Technical Support Bulletin 2014-04	MMP or ITP Inductive Transmission Timeout	September 3, 2014
---	--	--------------------------

Subject: IMM Timeout

Figure 1: New Sub-Directory Structure on CF

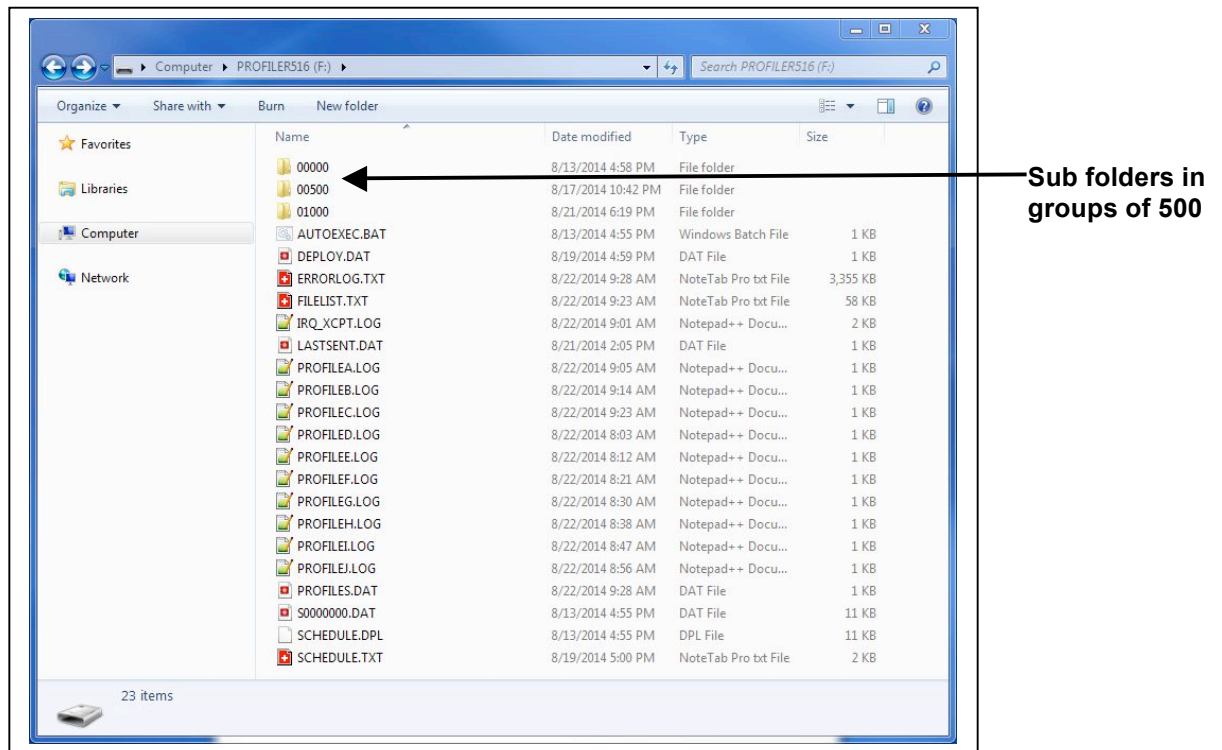
Technical Details: Due to a Sea-Bird Inductive Communications timeout, if more than approximately 4,500 data files are stored on the CF, the firmware cannot locate data files fast enough to meet the 30 second window required by the IMM. The offload then fails. This bug was identified in Profiler firmware v5.00-5.15 and affects only SBE Inductive Transmissions when greater than 4,500 files are collected on the CF Card.

Actions: Contact McLane to get Profiler firmware v5.16 and perform the upgrade on your system. Profiler v5.16 and higher have a new CF card directory structure (Figure 1). With the new structure, the firmware can locate and send data files to the surface controller within the 30 seconds required by the Sea-Bird IMM. For more information about the new directory structure refer to the Profiler v5.16 Release Note.
